**APPLICATION FOR PERMISSION  
UNDER SECTION 16 OF  
THE TOWN PLANNING ORDINANCE  
(CAP. 131)**

(b) Intended use/development 有意進行的用途／發展	Proposed Temporary Animal Boarding Establishment with Ancillary Facilities and associated Filling of Land for a period of 5 years

**Submission of Further Information (FI)**

**Further Information for Planning Application No. A/YL-TT/727****Response-to-Comments****Comments from EPD**

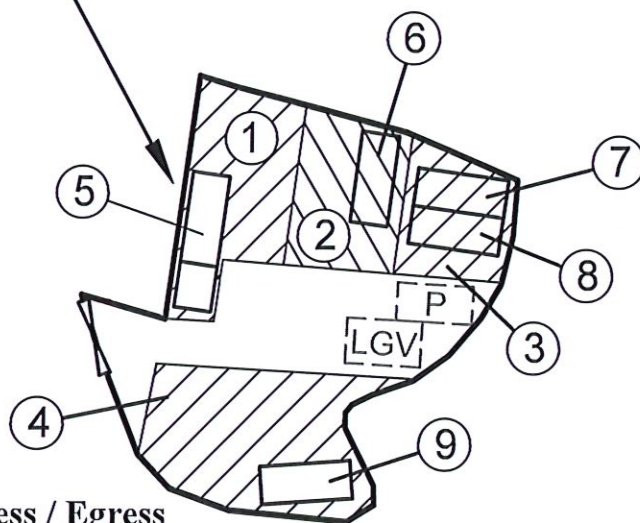
<b>I.</b>	<b>Comments</b>	<b>Responses</b>
1.	Please confirm that whether septic tank and soakaway system will be provided and if affirmative, whether the septic tank and soakaway system will be designed and constructed according to the requirements of EPD's ProPECC PN 1/23, including requirements for minimum clearance distance, percolation test and certification by Authorized Person.	Septic tank and soakaway system will be provided within the site. Please refer to the revised layout plan ( <b>Plan 3a</b> ) for the location of the toilet. The septic tank and soakaway system will be designed and constructed according to the requirements of EPD's ProPECC PN 1/23. The applicant will employ licensed collectors to collect and dispose the sewage generated from the proposed use regularly.

2.	Please ask the applicant to clarify how the wastewater generated from the proposed use (e.g. faeces and urine from the animals) will be treated.	Ditto.
